GH505.0 / GH506.0 / GH606.0/ GKH507.0**Important information****Please take special care when changing the connection end.**

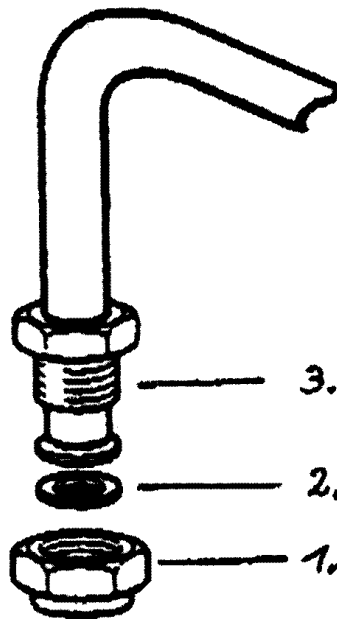
The procedure for changing the blanking cap [1] is as follows:

1. Unscrew the blanking cap from the collar [3] (use 2 SW24 spanners).
2. Dispose of the old copper gasket [2] and replace with new copper gasket (comes with the appliance)
3. Place the blanking cap on the collar on the other side, close tightly with 2 SW24 and test the seal.

From November 1998, the aluminium blanking cap is to be replaced by a brass blanking cap.
